# CHANGE ORDER

PROJECT: **Loeb Stadium**  
*(Name and address)* **Main Street and Wallace Street**  
**Lafayette, Indiana**

CHANGE ORDER NO.: **BP8-9**

**6617.095 - As it relates to the electrical revisions for the concessions equipment and the exterior GFCI's.**

### Cost item #1 – \$1,713.16

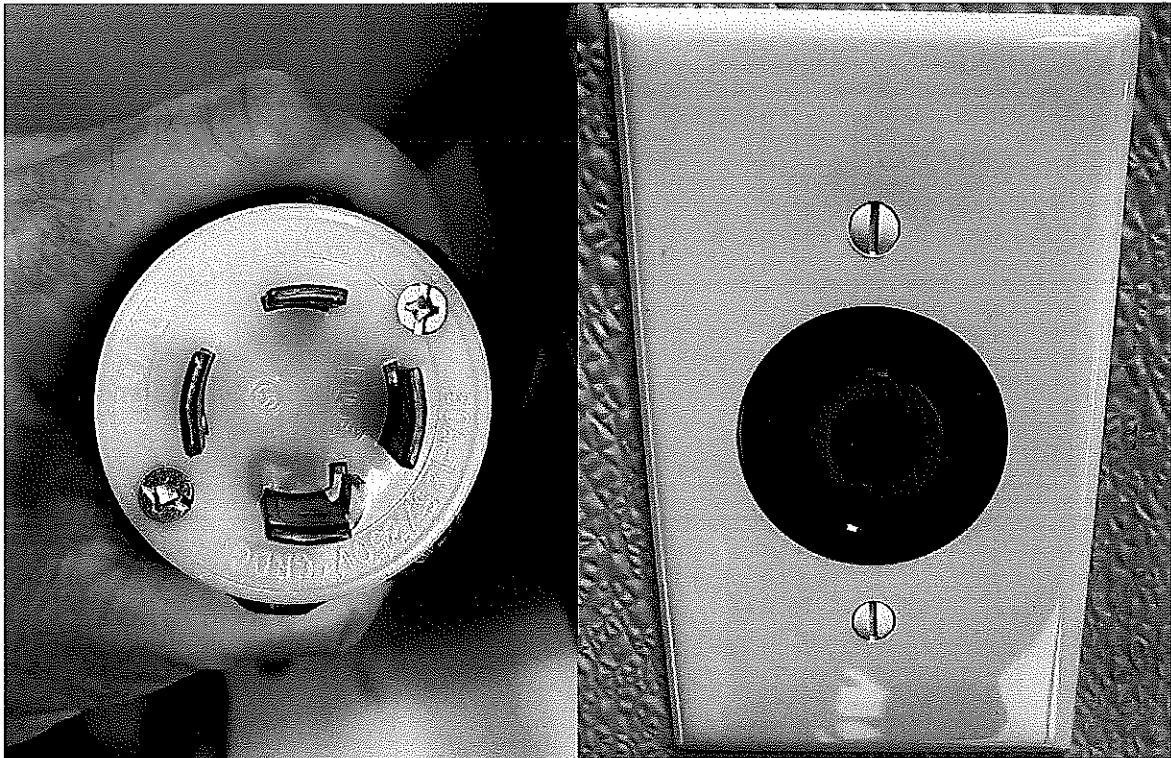
KCI directed Huston to install off the approved kitchen equipment drawings. No where in the kitchen drawings nor the Electrical drawings did it show GFCI devices to be all in the so called "food prep area" and the City inspectors required these to be therefore Huston had to change these devices out. In total there were 27 GFCI devices that needed to be added.
